**SQSS Review Panel – Modification Proposal**  
**Updating the SQSS to reflect the recent modification to Engineering Recommendation P28**

**Date Raised: 10 09 2018**

A Panel Paper by Rachel Woodbridge-Stocks & Greg Heavens  
National Grid Electricity System Operator

The minimum time required between two consecutive operations causing a Voltage Step Change of a specific level are shown in Figure 1 below for both P28 Issue 1 and Issue 2.

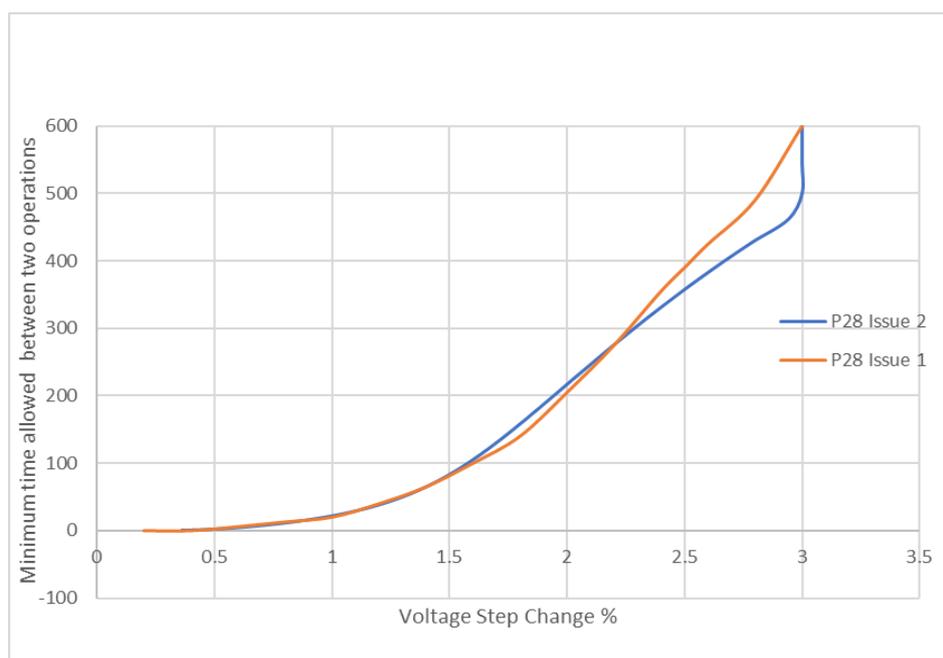
Therefore, a sequential modification is required to the SQSS to update the reference to the “Minimum time interval between voltage changes” diagram which has been updated in Issue 2 of P28. It is proposed that the new diagram will replace Figure 6.1.

- Change the 10 minutes referred to in Row 1 and Row 2 of Table 6.5 of the NETS SQSS to 8 minutes; and
- Replace Figure 6.1 of the NETS SQSS by Figure B.1.2 of the new EREC P28 Issue 2.
